MEMORANDUM

TO	Emma McGivern	COMPANY	Rio Tinto
FROM	Sean Campbell	OFFICE	Melbourne
EMAIL	seanc@atcw.com.au	PHONE	03 8587 0900
PROJECT TITLE	Winu Copper Gold Project		
SUBJECT	Winu Site-Wide Water Balance Peer Review		
DATE	21 May 2025	OUR REF	124050.02 Rev2

Figure 1 - Climate forecast percentage change in annual mean rainfall

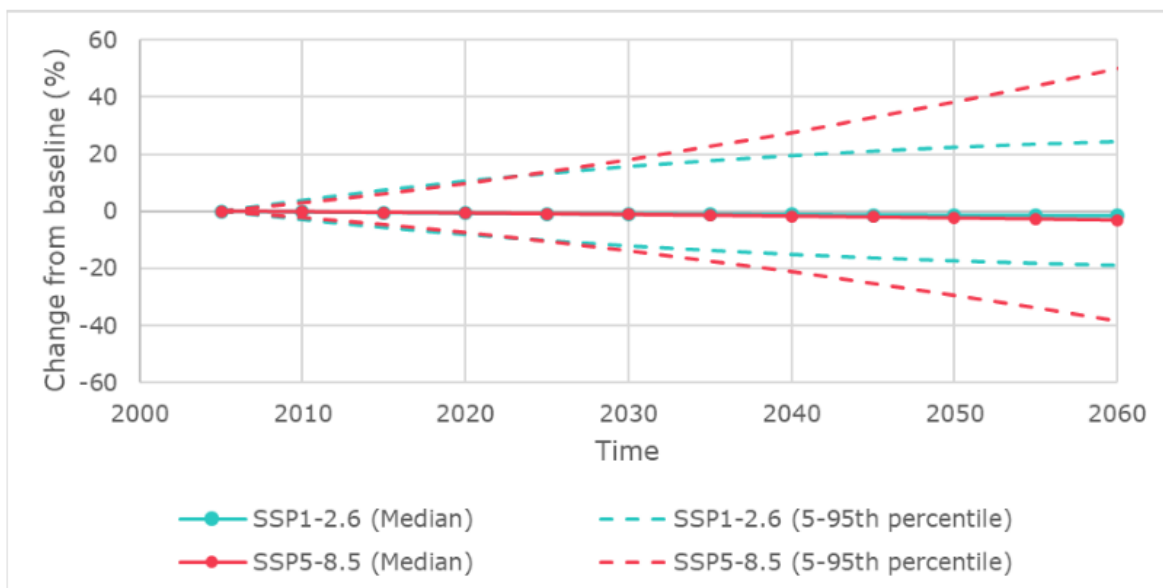
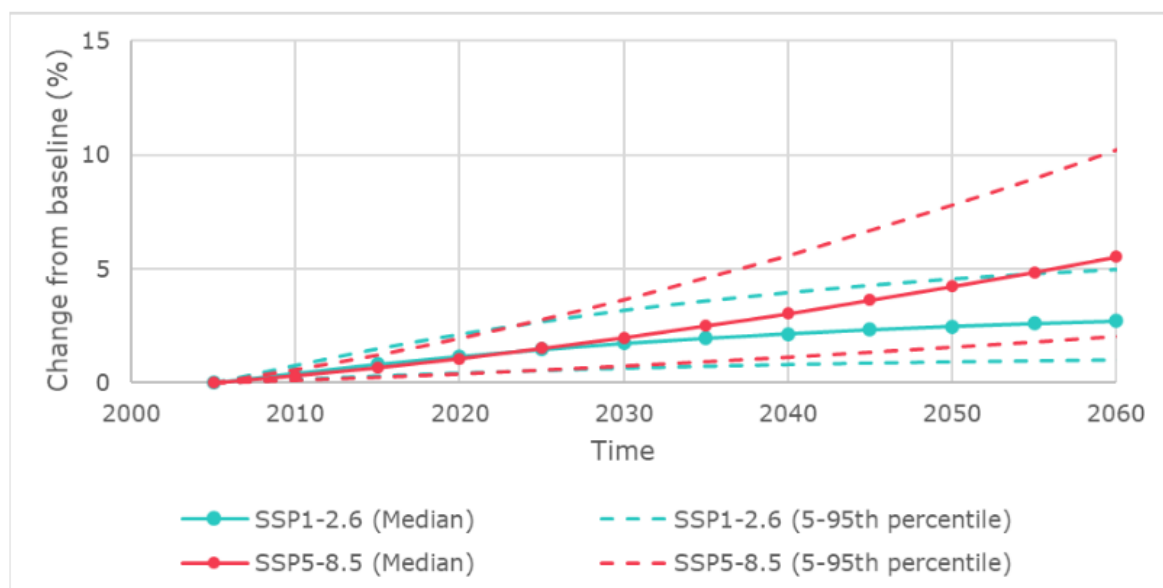
A sensitivity analysis was performed using scenarios based on the emission, rainfall percentile and evaporation percentiles outlined in **Table 1[1]**. The forecast changes in mean rainfall and evaporation (from the Water Balance Report [1]) are shown in **Figure 1** and **Figure 2**.

While the sensitivity analysis is understood to be a high-level assessment of the potential impact that climate change may have on the outcomes of the water balance, the scenarios that apply the 5th and 95th percentiles may be compounding and overly conservative as statistical extremes don't necessarily coincide. This approach may be fit for the purposes of this study, however, it is recommended that future modelling assesses the application of the climate change percentiles.

Figure 3 - Plant Water Demand

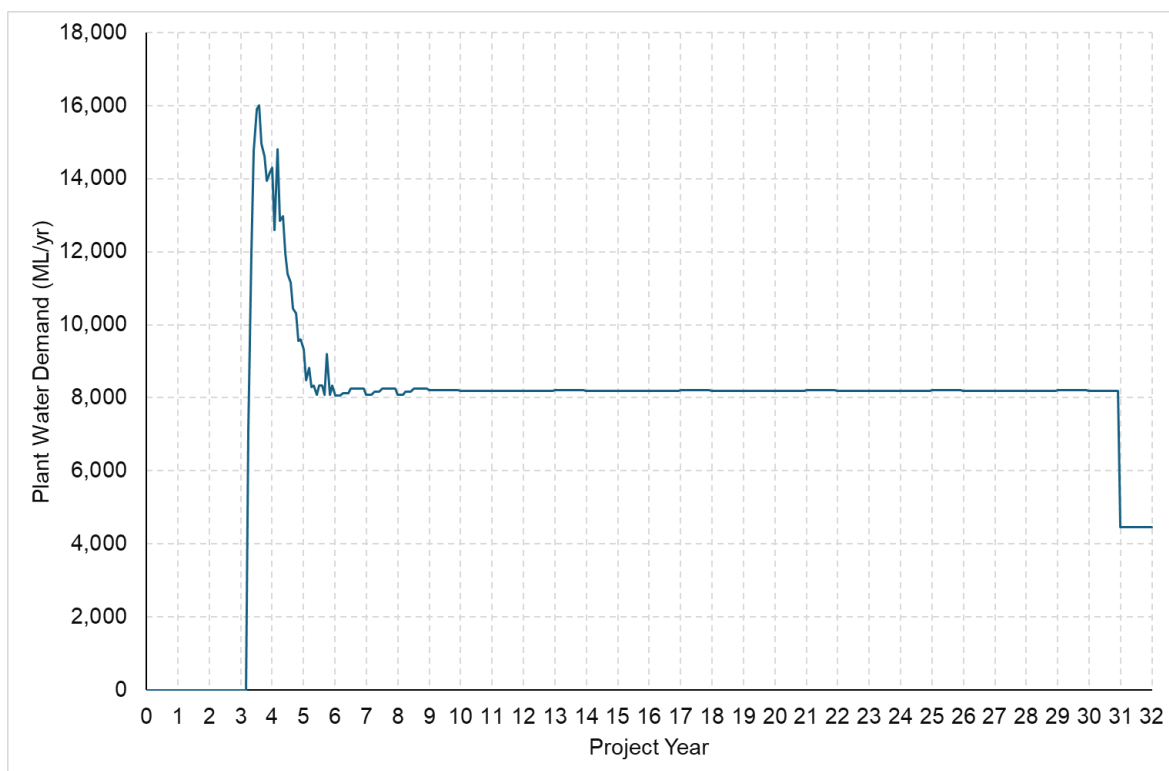
The ramp up of the solids content increase the plant water demand and the volume of contaminated water that is stored in the TSFs.

The plant water demand peaks during the ramp up period at approximately 16,000 ML/yr, close to double that during the remainder of the Project. This is shown in **Figure 3** below.

The approach of adopting a ramp up of solids content is conservative and shows the potential requirements for water demand and water storage due to the lower tailings solids content. However, if the tailings team can determine that higher solids content can be achieved during the start up period this will greatly reduce challenges in water management.

Figure 4 - Low Sulphur Pond Volume

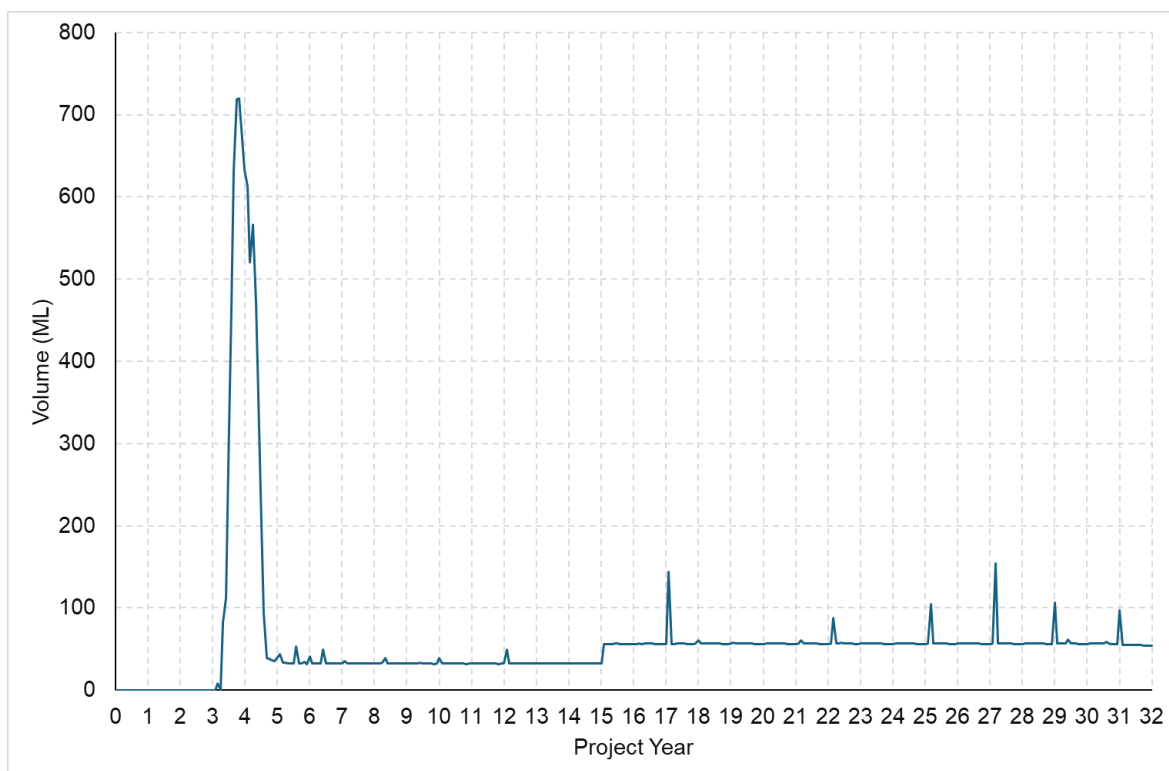
Figure 4 shows that the Low Sulphur TSF pond volume peaks at approximately 720 ML during the ramp up period, more than seven times the operating volume for the remainder of the Project. It is recommended the Low Sulphur TSF pond volume results are presented in the Water Balance Report [1] to highlight the volume of water stored in the facility over the ramp up period to assist in design and water management requirements.

Figure 5 - Total TSF Storage Volume Probabilistic Range

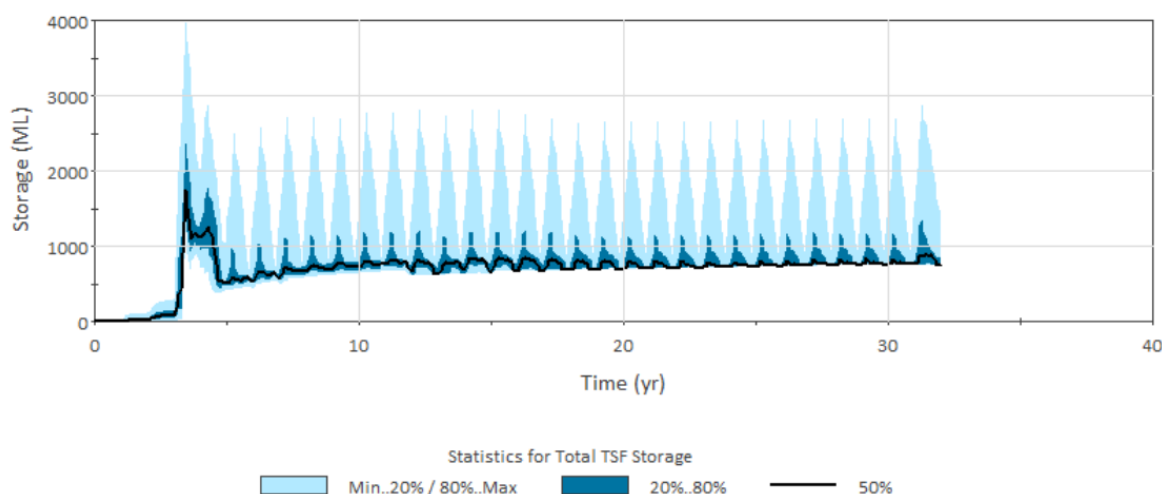
Figure 5 [1] shows the probabilistic results of the total TSF storage volume, where the maximum volume of water stored in the combined TSFs (High Sulphur, Low Sulphur and Reclaim Ponds) is during the ramp up period.

Figure 6 - Annual Mine Dewatering Rates [1]

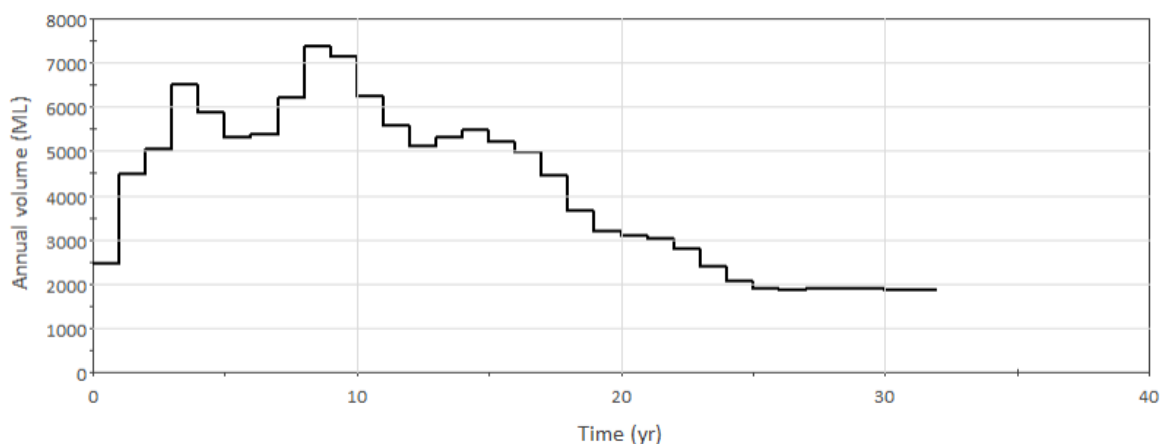
Figure 6 shows the estimated annual dewatering volumes are highest over years 0-17, peaking in year 8 at approximately 7,400 ML/yr. From year 17 to 25 annual dewatering decreases from 5,000 ML/yr to 2,000 ML/yr, where it remains constant to the end of the modelled period.

The modelled water excess and water demand are shown in the report to be largely influenced by the dewatering volumes. ATCW recommend that the water balance model is reviewed following the collection of dewatering data and verification of the groundwater model.
